ROCKY MOUNTAIN ARSENAL
NORTH BOUNDARY SYSTEM COMPONENT
RESPONSE ACTION ASSESSMENT

FINAL TECHNICAL PLAN
MAY 1988
CONTRACT NUMBER DAAK11-84-D-0016
TASK NUMBER 36

Final Technical Plan
(Version 3.2)

Figure 3.2-2a
GENERALIZED BEDROCK AQUIFER MONITOR WELL CONSTRUCTION
(DENVER FM. WELL COMPLETED IN FIRST SANDSTONE, ALLUVIUM
UNSATURATED, SANDSTONE AT THE ALLUVIAL-BEDROCK CONTACT,
SANDSTONE PARTIALLY SATURATED)

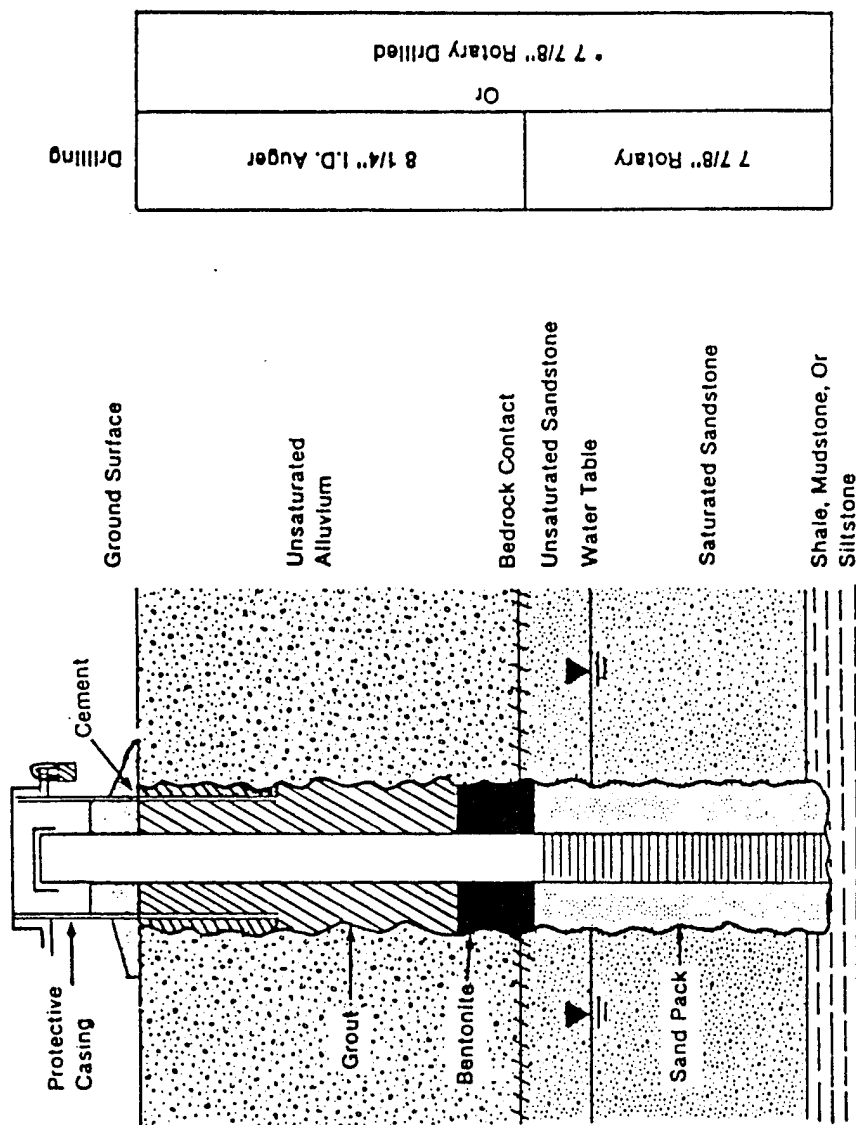
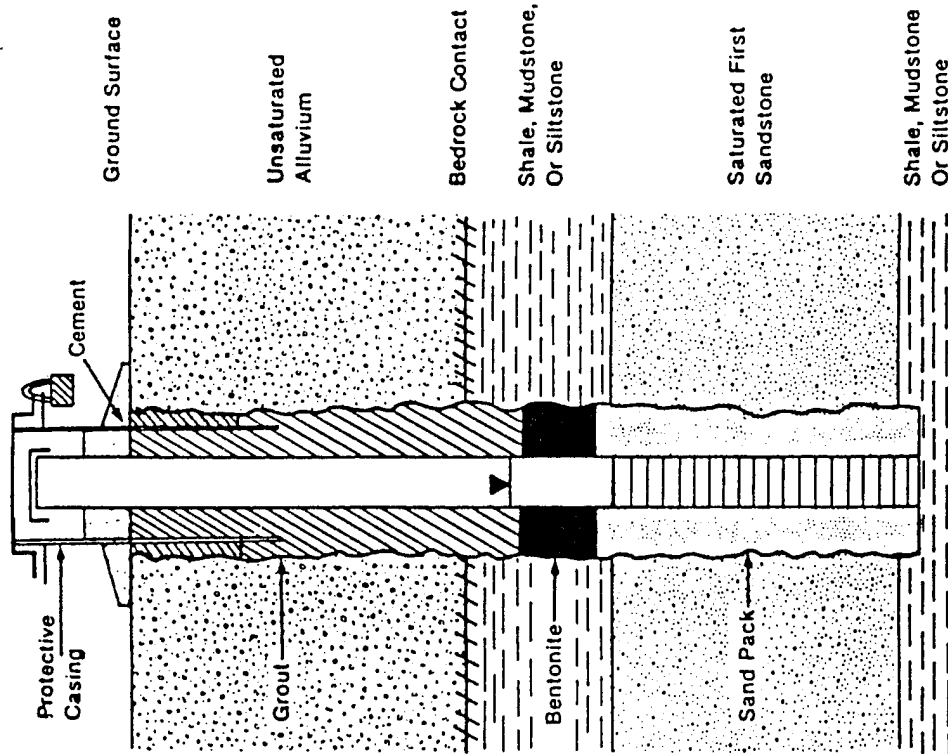
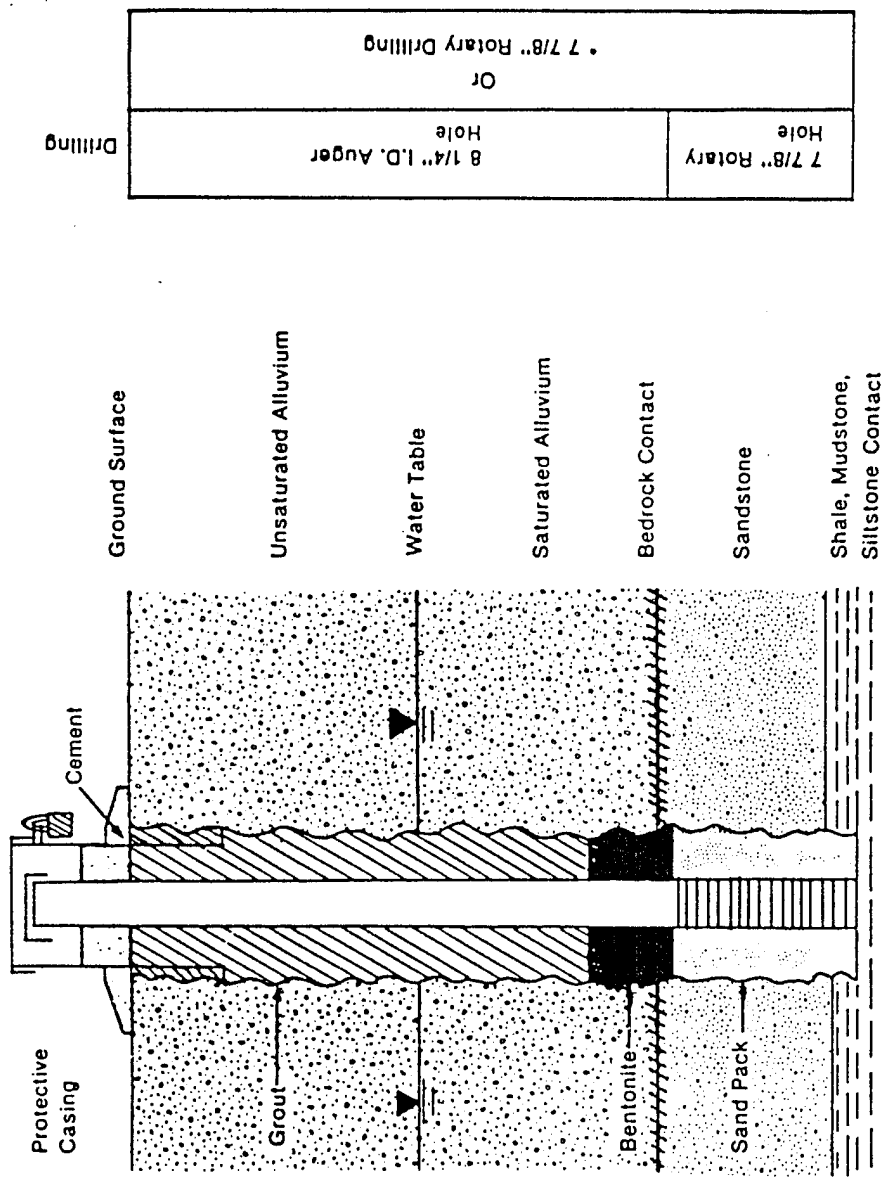
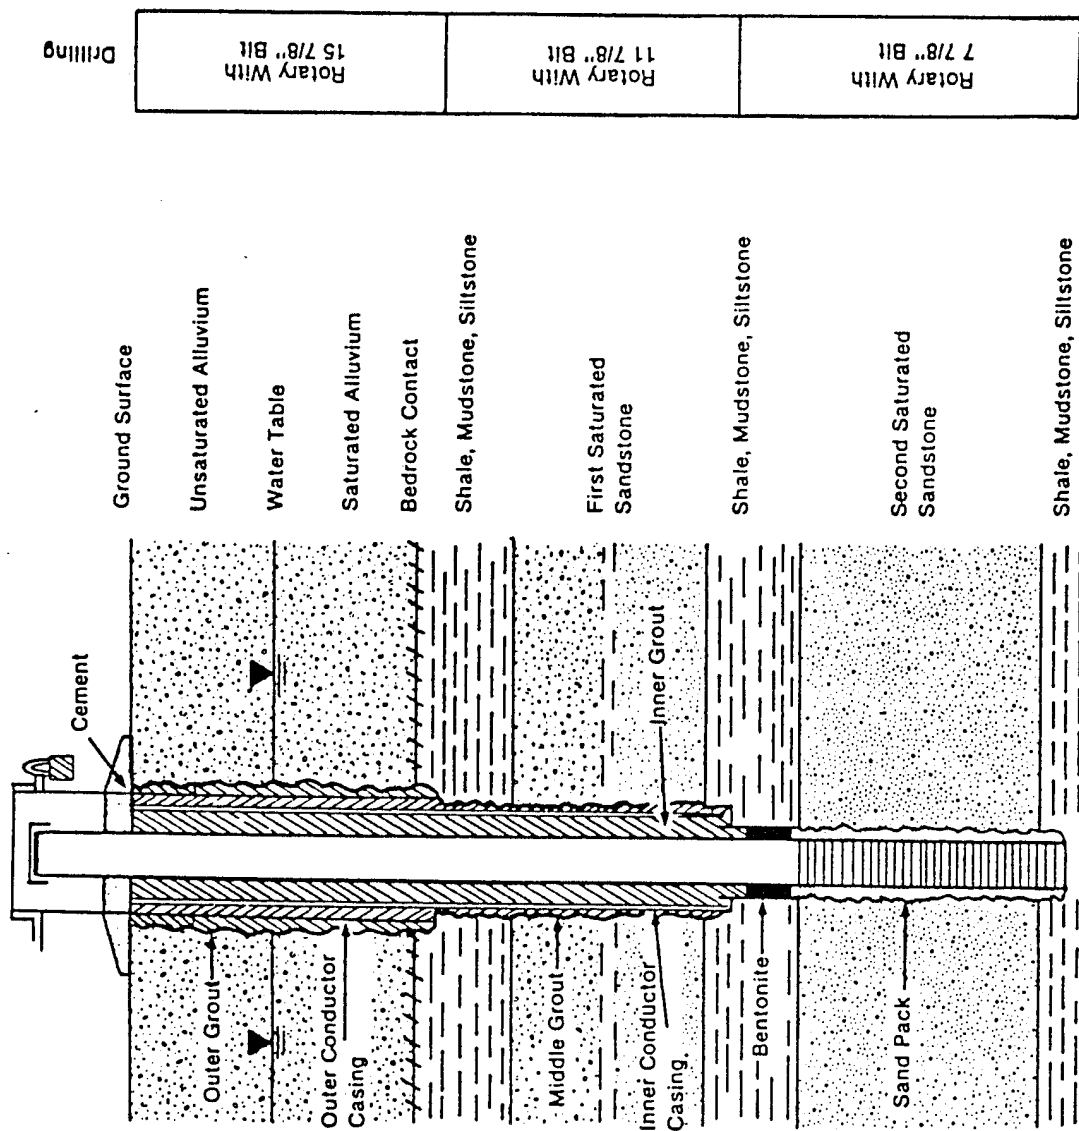
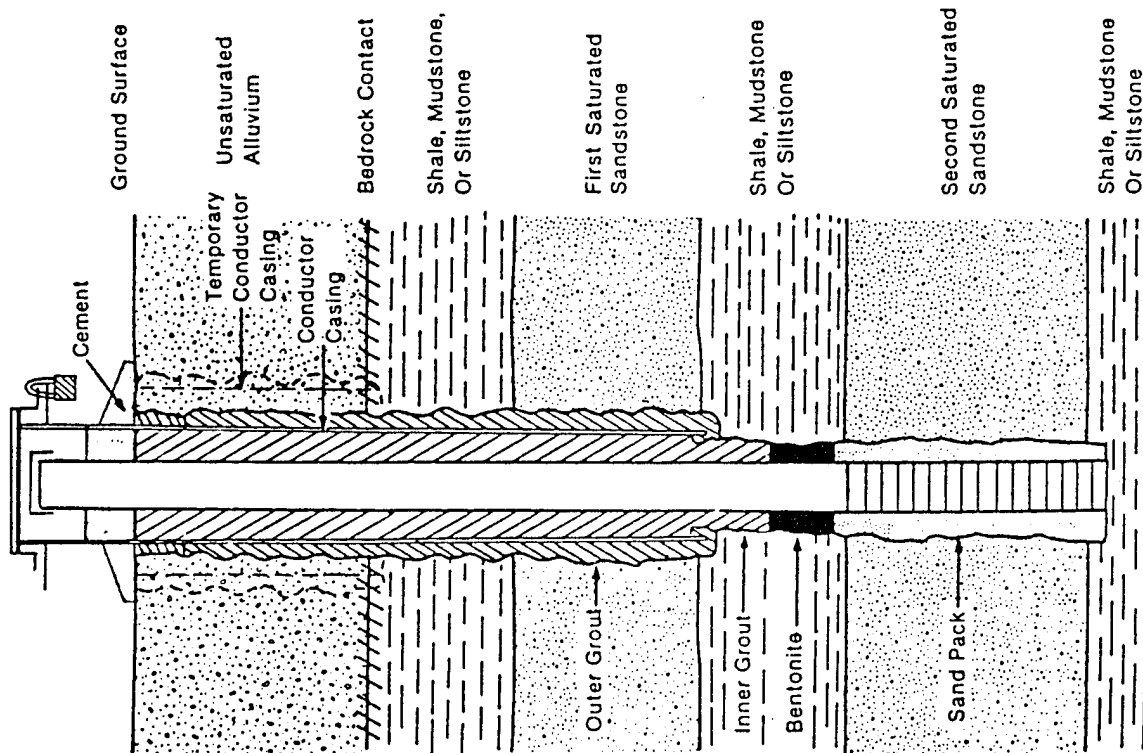
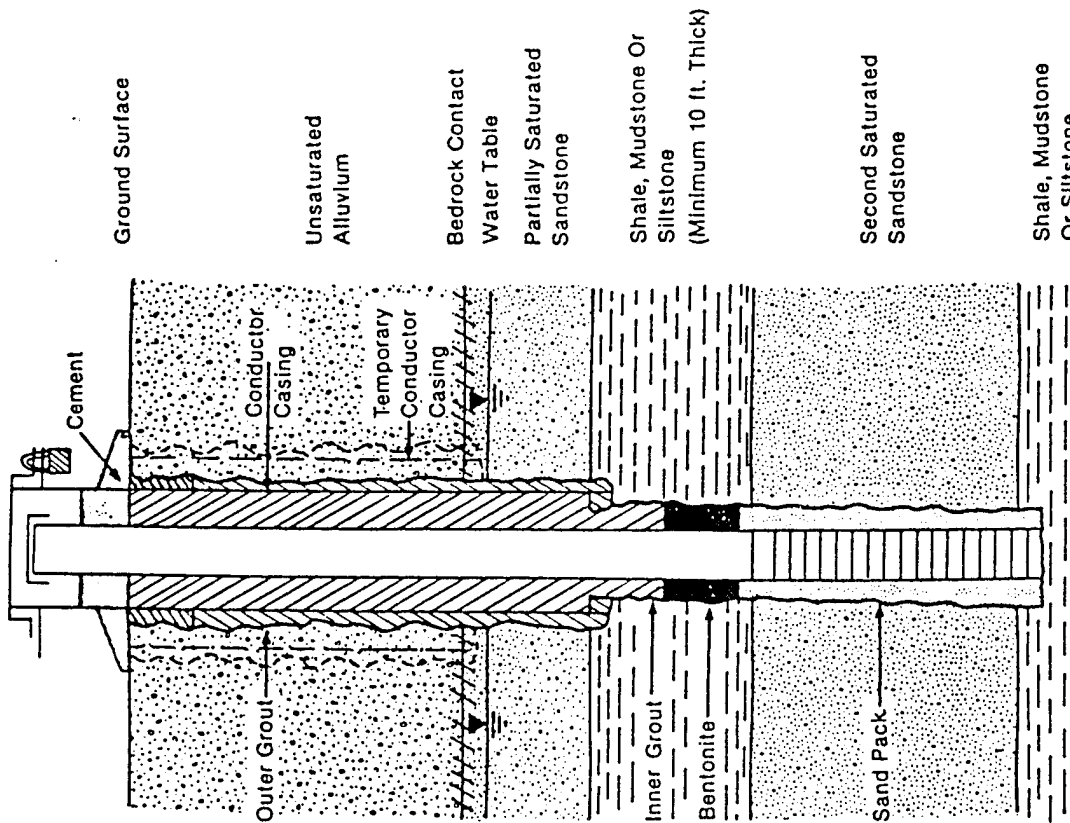
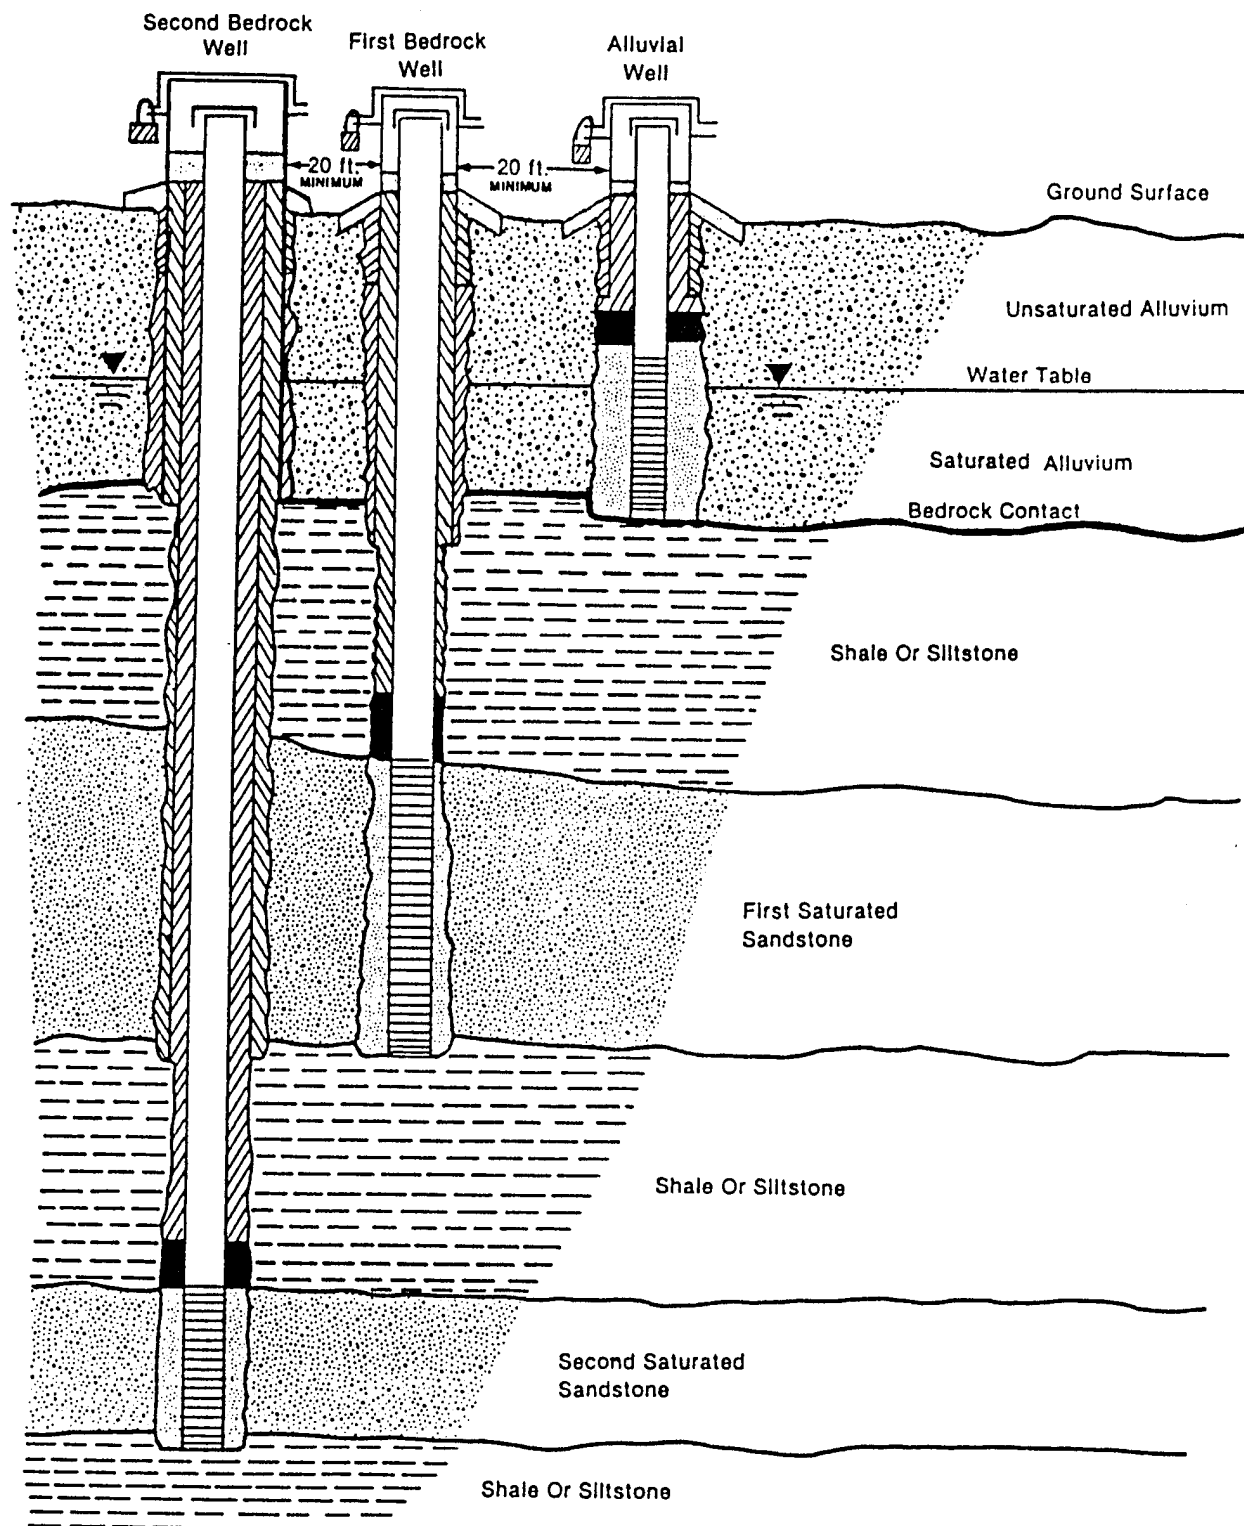
Figures 3.2-2a through 3.2-3. Construction details and contingencies for installing monitoring wells in shales/claystones of the Denver aquifer that show evidence of fracturing must be included in the technical plan.
